**PZ25-12000009****09/03/2025**

**Subject:** RE: 117 S Riverside Drive OH Lines

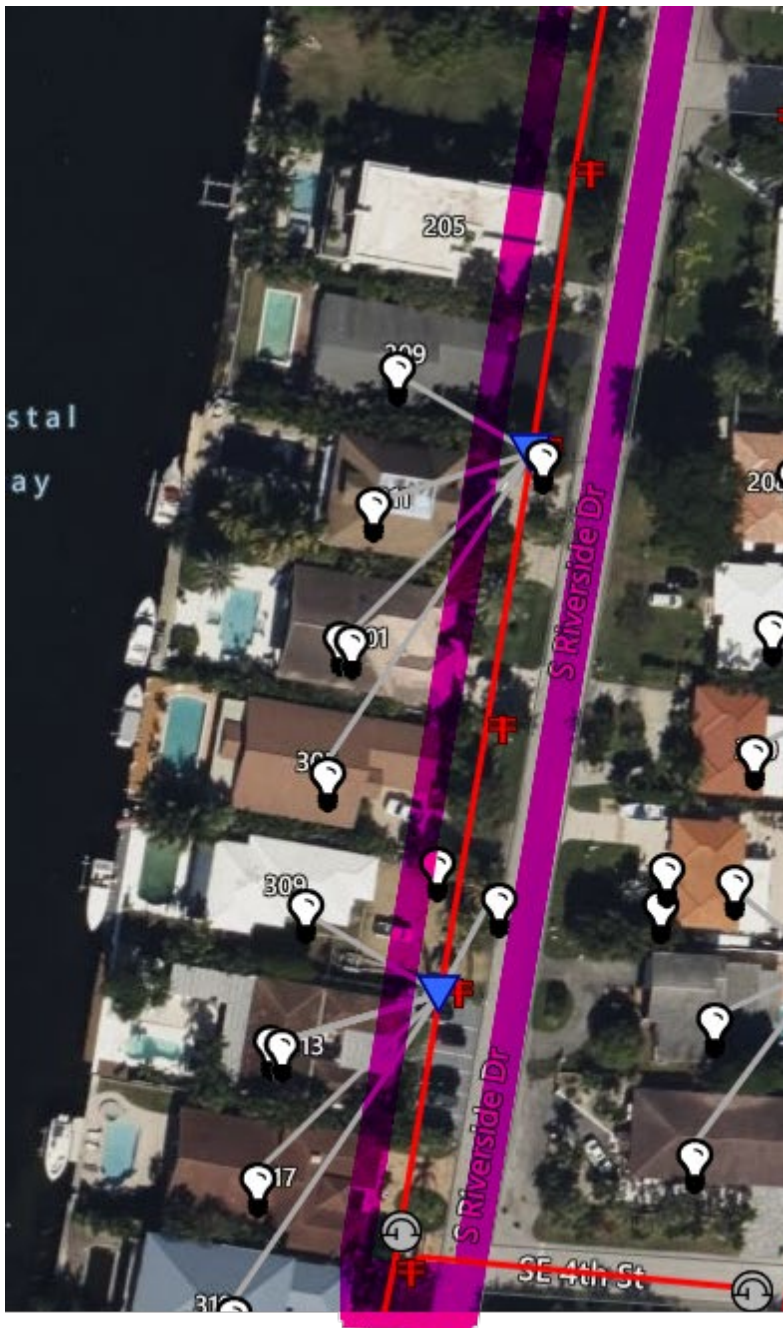
Unfortunately, we cannot underground only the section of overhead lines crossing over the requested property due to reliability concerns. However, if you are interested in proceeding with the underground conversion of the area along S Riverside Dr, it would need to cover the section highlighted below. Here is some additional information to assist in your decision-making:

- A ballpark estimate for the conversion is approximately \$275,000 payable to FPL. However, this does not represent the total cost incurred during the process.

- Your team will be responsible for contacting each property along the lateral line being converted to provide easements for FPL's underground facilities to be placed within.

- Your team must obtain approval from each affected customer along the lateral line, showing their consent to the conversion and proposed facility installation locations.

- Your team will be responsible for coordinating the conversion of all customers on this section of the lateral line to an underground service/meter can up to the transformer.

- Your team will need to coordinate with all telecommunications and CCTV companies attached to the pole line to ensure their removal/undergrounding process coincides with ours.

- A non-refundable engineering deposit must be paid to FPL, which can be applied to the final cost if your team chooses to move forward once the design is completed.

- Permanent service for the new construction may be delayed until the conversion is completed, a process that may take upwards of 2-3 years.
